CITY OF GLENDALE, CA

DESIGN REVIEW STAFF REPORT - SINGLE FAMILY

November 14, 2023 1257 Linden Avenue

PADR-001745-2023 Paul Bazerkanian

exist'a Landscaping To Remain FKISTING. RANTER CHEW LOCATION CE EXISTICA 23-3" LPROPOSED 6'X12' B.B.Q. AREA SITE PLAN

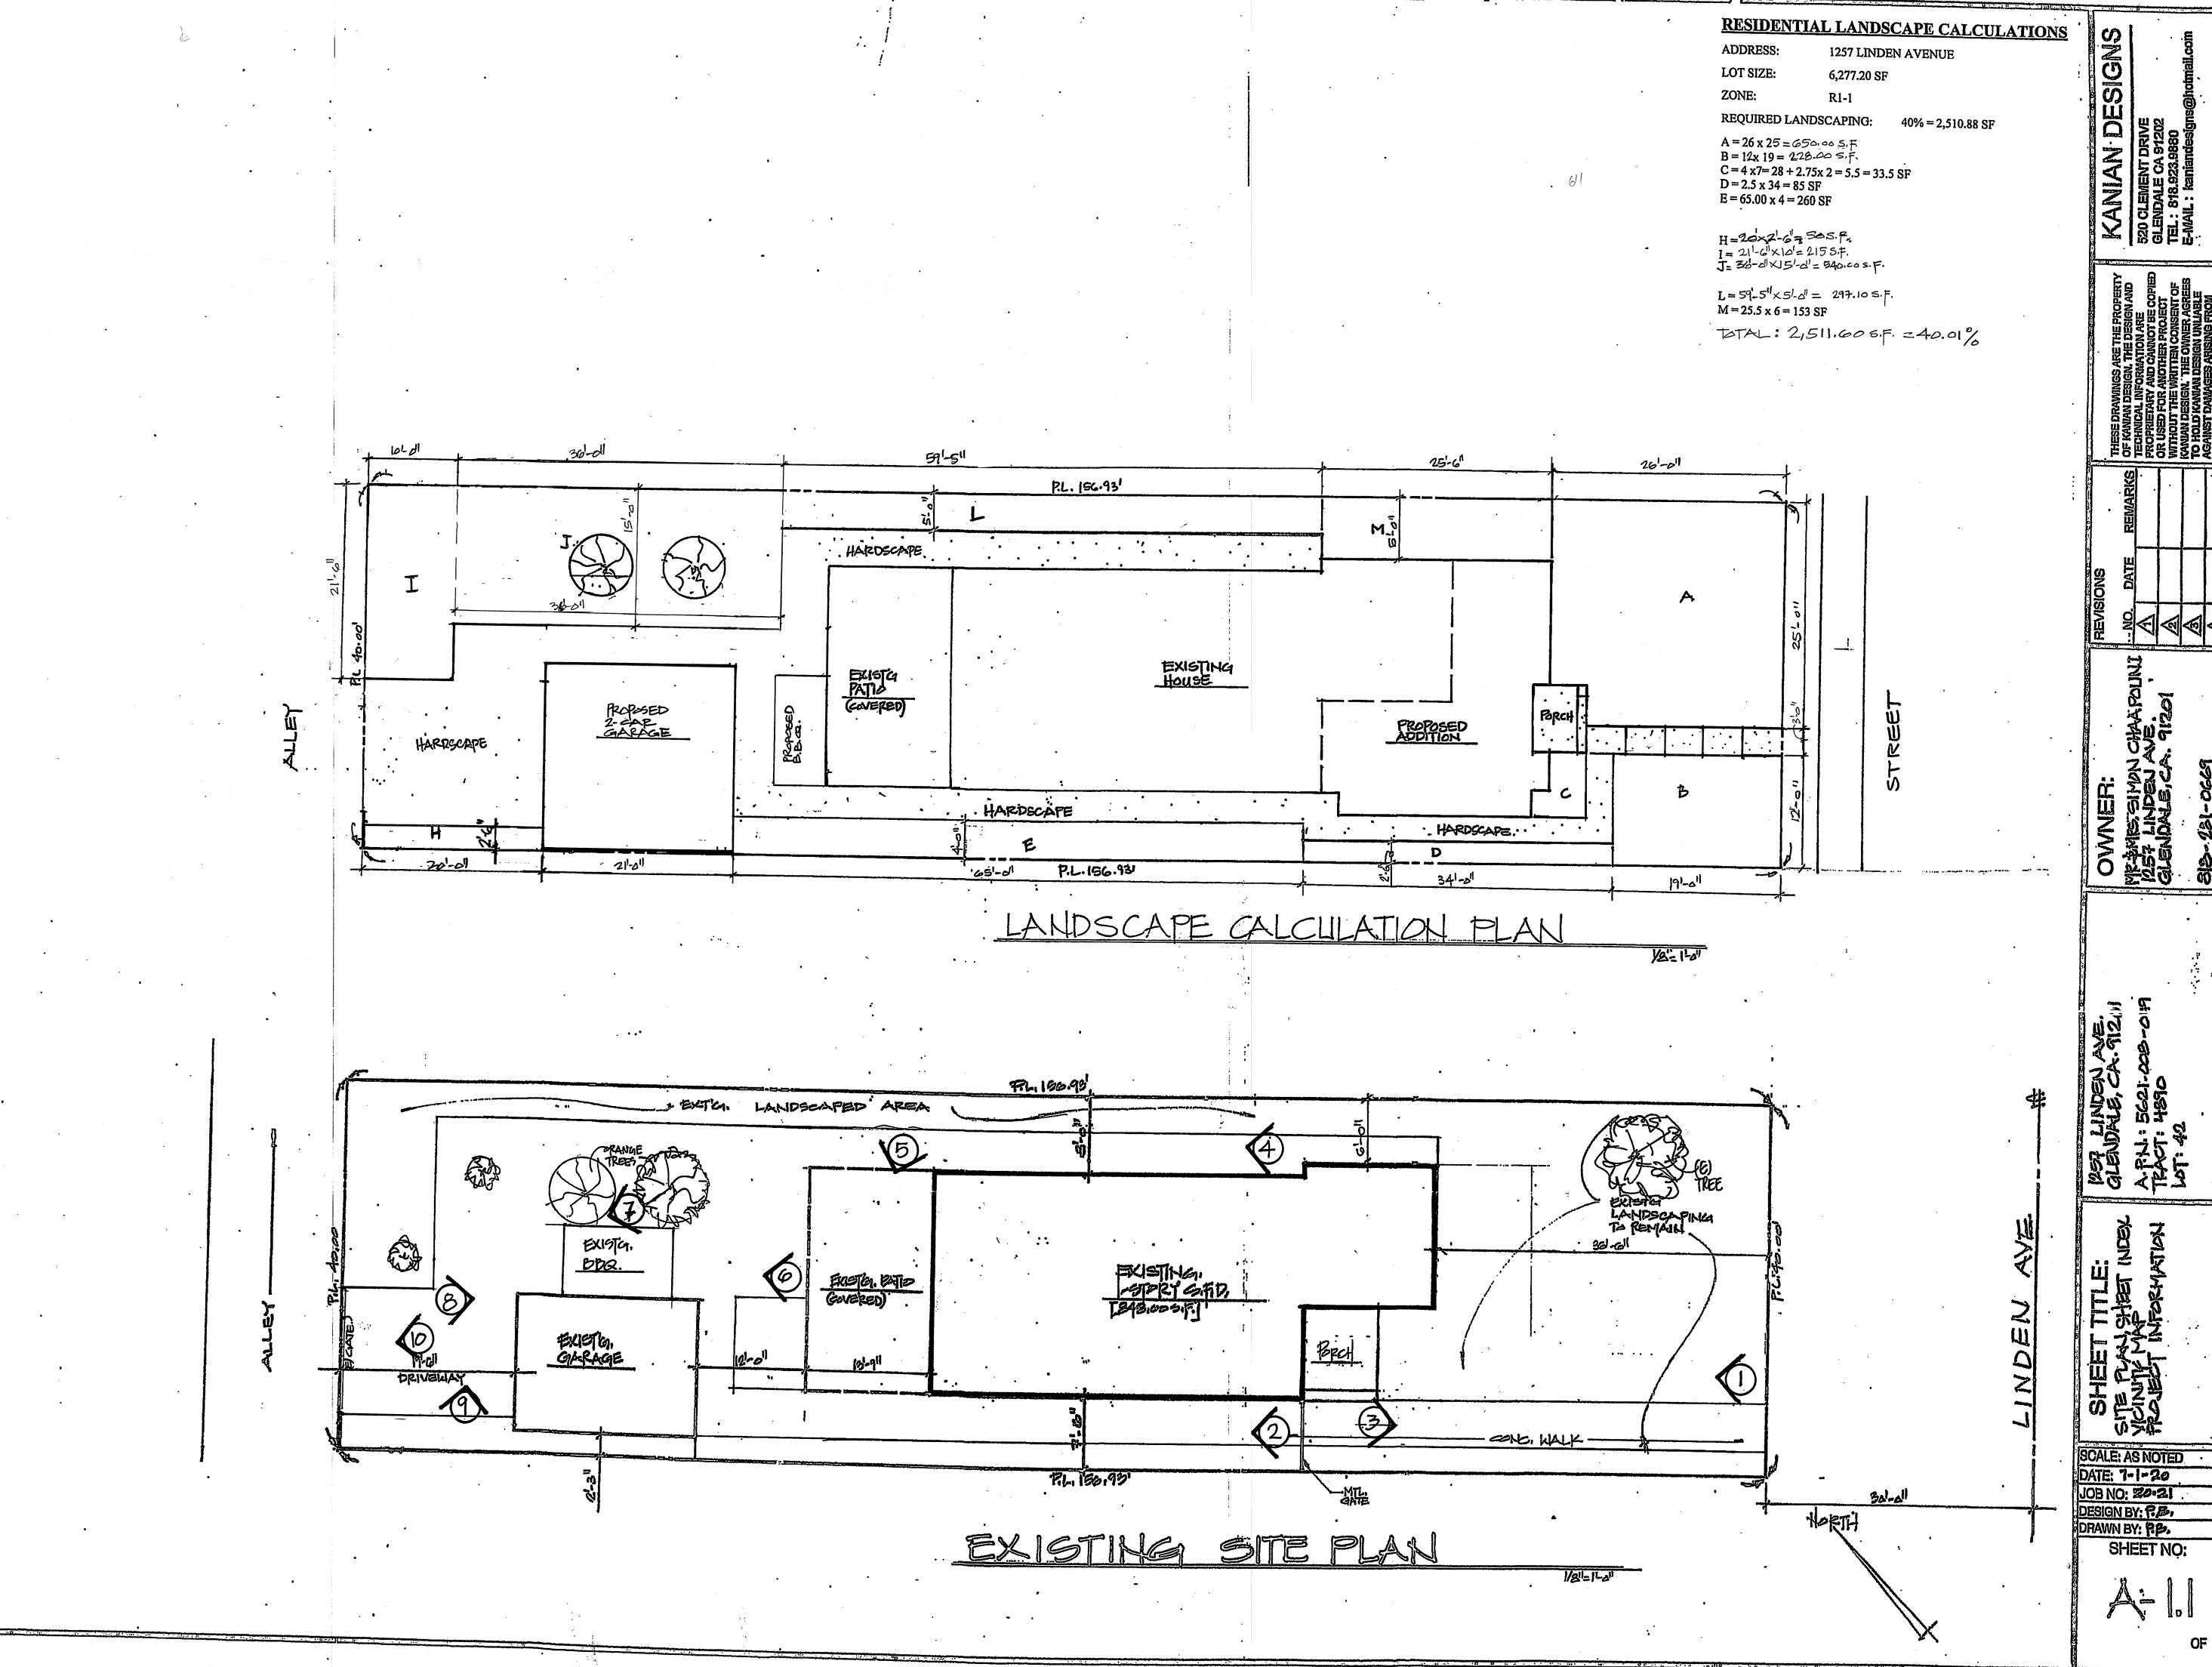
If no select from below and explain: ☑ Complementary to building design ☑ Maintains existing trees when possible ☑ Maximizes permeable surfaces ☑ Appropriately sized and located
A landscaping plan indicating plant type, location and size has not been provided. New hardscape areas are not shown as featuring permeable surfaces.
Walls and Fences ⊠ yes □ n/a □ no
 If "no" select from below and explain: □ Appropriate style/color/material □ Perimeter walls treated at both sides □ Retaining walls minimized □ Appropriately sized and located
Determination of Compatibility: Site Planning
The proposed site planning is appropriate, as modified by any proposed conditions, to the site and its surroundings for the following reasons:
 The front and prevailing setbacks are maintained. Placement of the new detached garage at the rear is consistent with the street pattern. Existing trees on site that are not in the location of the addition are maintained; however, proposed planting material for new landscaped area has not been specified. A condition of approval ensures the landscaping will be appropriate to the design and native/drought-tolerant. Hardscape areas are not shown as featuring permeable paving. A condition of approval ensures permeable paving will be used where feasible. A new fence/gate is added at the north property line, stepped back from the front façade; the front yard remains open. The new gate will match the appearance of the existing wrought iron gate on the south property line. The trash collection area and mechanical equipment are located outside of public view, screened by a fence.

Paving Materials □ yes □ n/a ⊠ no	
 If "no" select from below and explain: □ Decorative material at entries/driveways ⊠ Permeable paving when possible □ Material and color related to design 	
Permeable paving has not been shown. A condition of approval recommends use of permeable paving where feasible.	of
Lighting, Equipment, Trash, and Drainage □ yes □ n/a ⊠ no	
If "no" select from below and explain: □ Light fixtures appropriately located/avoid spillover and over-lit facades □ Light fixture design appropriate to project □ Equipment screened and well located □ Trash storage out of public view □ Downspouts appropriately located □ Vents, utility connections integrated with design, avoid primary facades	
Lighting fixtures have not been shown. A condition of approval ensures any propos lighting fixtures will be appropriate to the style.	ed
Ancillary Structures □ yes ☑ n/a □ no If "no" select from below and explain: □ Design consistent with primary structure □ Design and materials of gates complement primary structure

- A landscaping plan shall be provided for new landscaping areas, indicating number and types of plants, and demonstrating they are complementary to the building design and native/drought-tolerant.
- Permeable paving shall be used where feasible.
- Stucco siding finish shall be a smooth finish.
- Siding wrapping the north façade shall extend the full length of the façade, not terminate at the gate.
- Any exterior lighting fixtures to be used shall feature a style and proportion consistent with the architectural style.
- Specific window product information shall be provided, including manufacturer, material, color, and window type. Any window grids visible from the street shall be external grids.
- Rain gutters/downspouts shall be appropriately placed to complement the adjacent materials and/or colors.

EAST ELEVATION

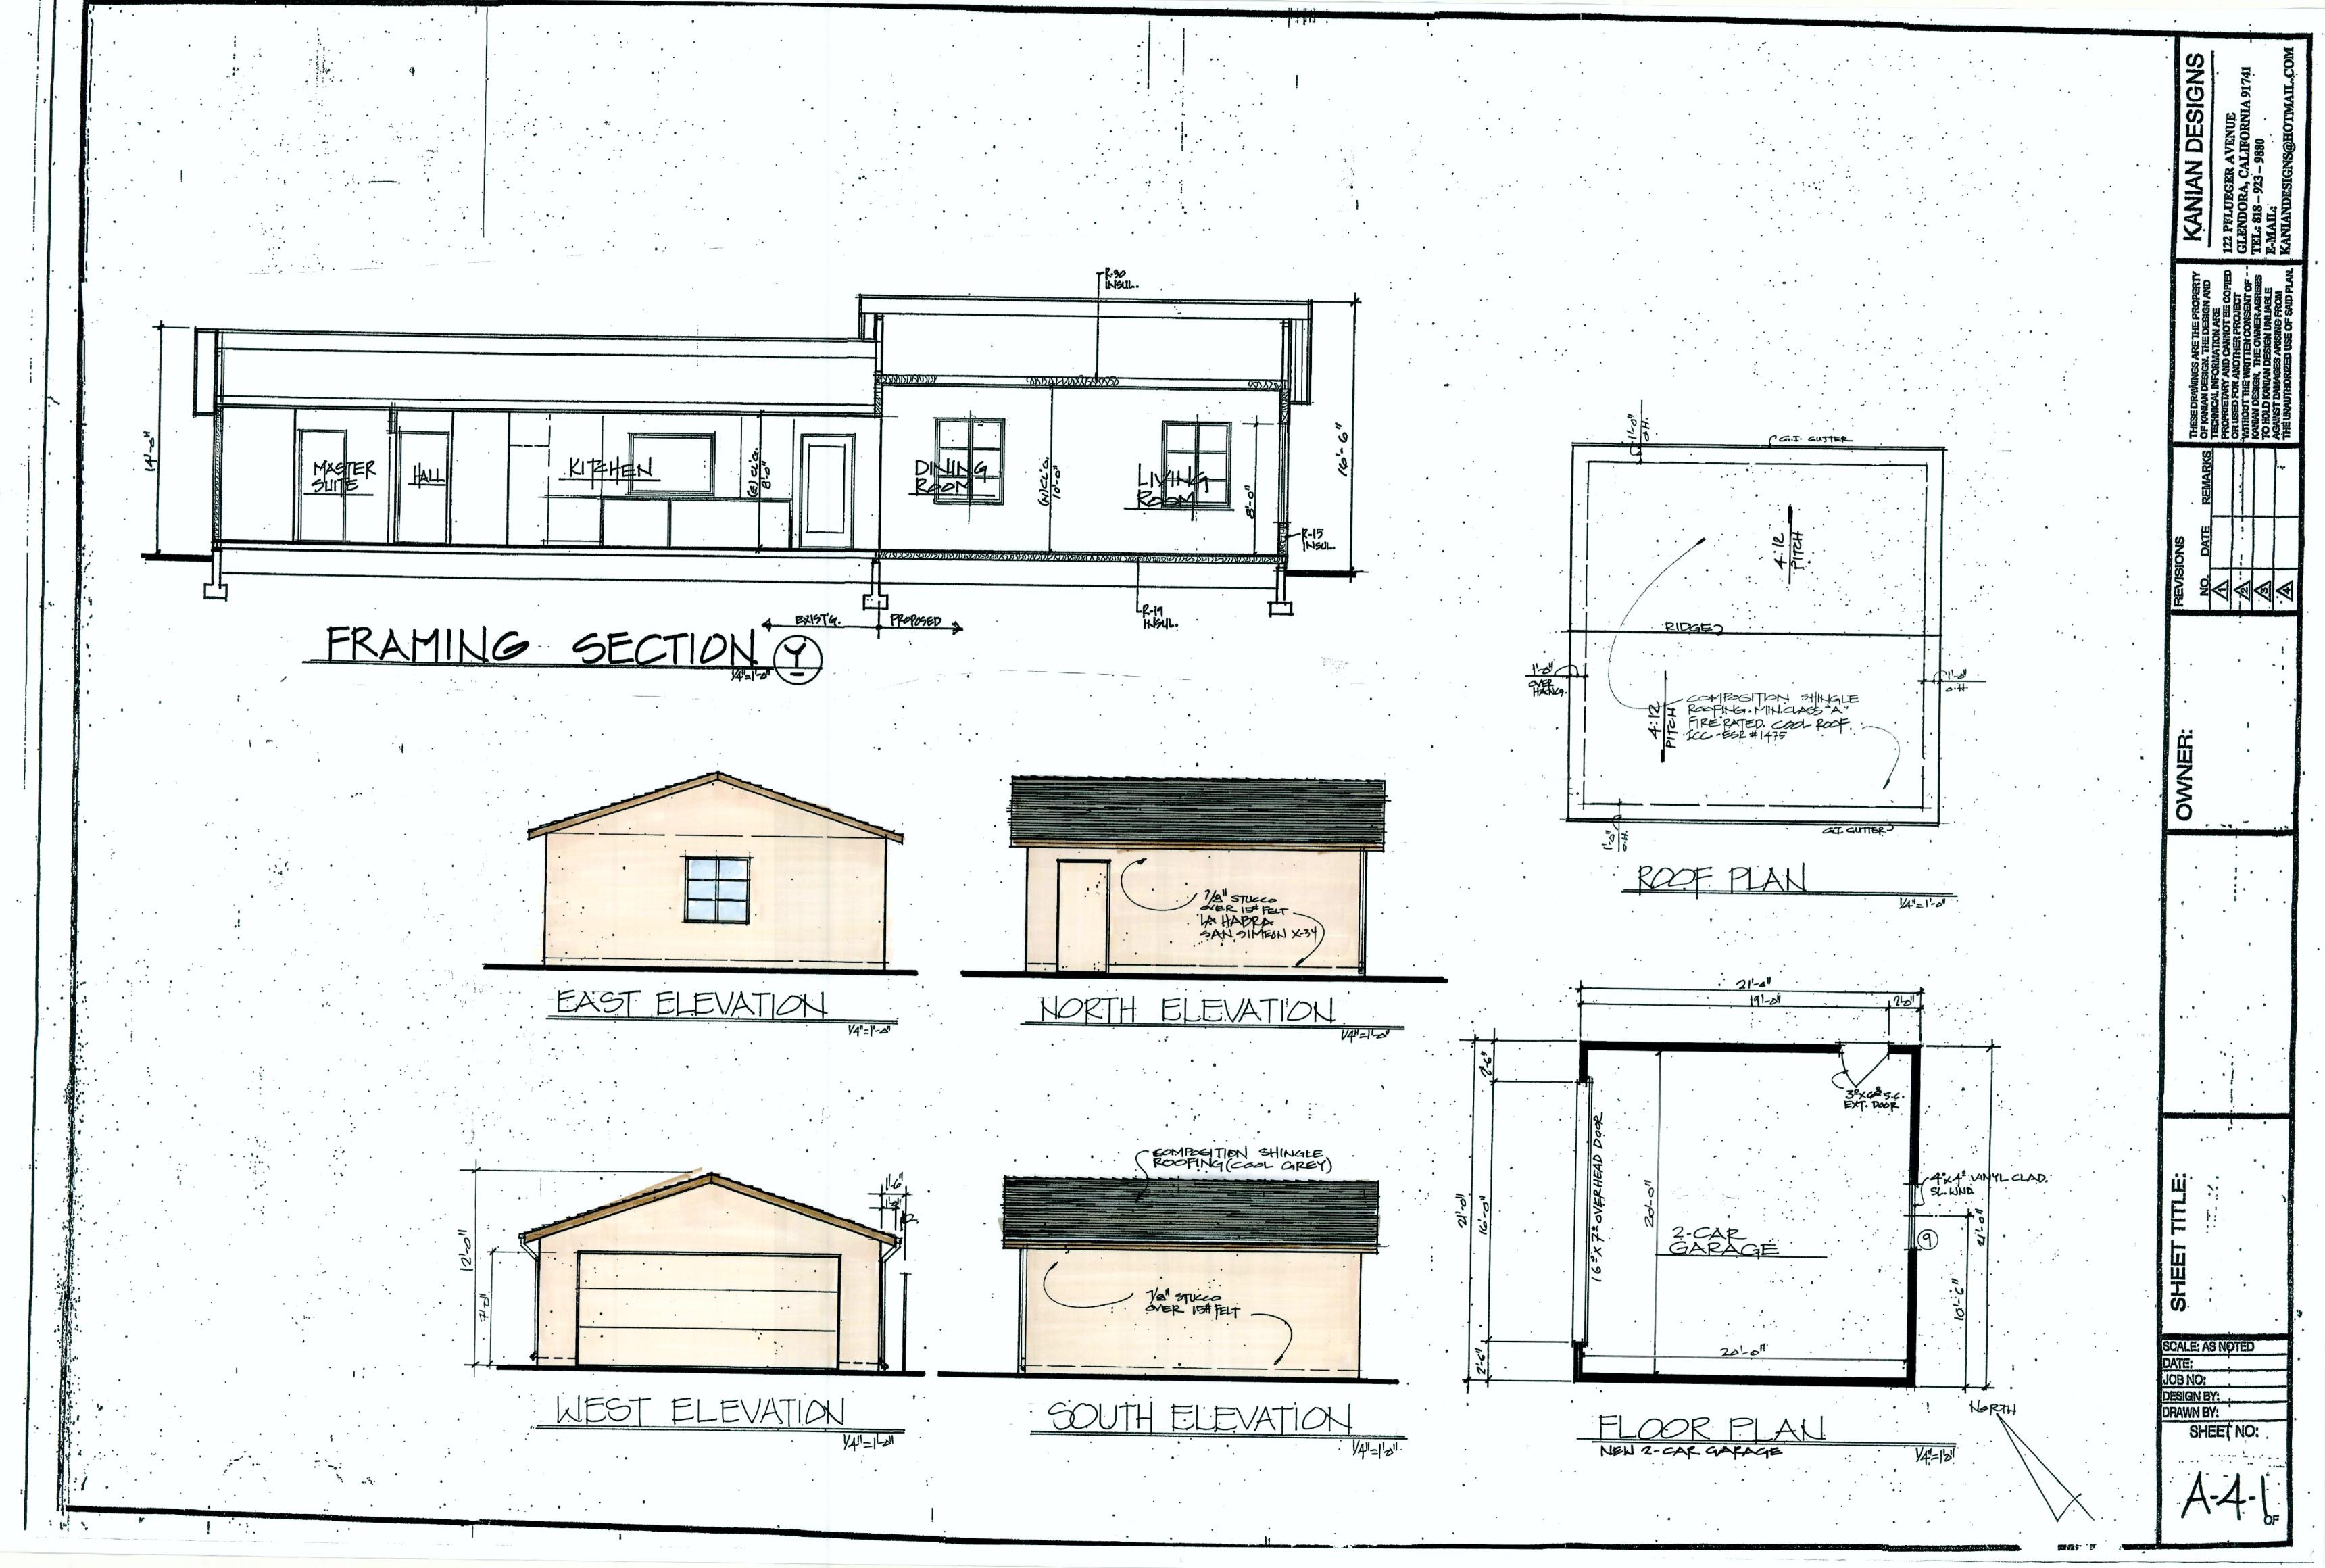
- Windows are recessed with sill, non-sliders, consistent with the existing traditional style home and the predominant neighborhood pattern. Windows are indicated in the window schedule as not featuring external grids, however, they show a grid pattern. A condition of approval ensures specific window product information will be provided demonstrating if grids are used they must be external grids.

- Although stucco joints are featured, adding additional architectural detailing, the stucco finish has not been shown. A condition of approval has been added to ensure a high-quality smooth finish.

- Siding on front façade wraps corners and terminates at logical end points; however
 the siding wrapping around the north façade needs to extend the full length of the
 façade rather than terminating at the gate. A condition of approval has been added
 to address this.

- Rain gutters/downspouts have not been shown. A condition of approval has been added to ensure they are well integrated into the design.
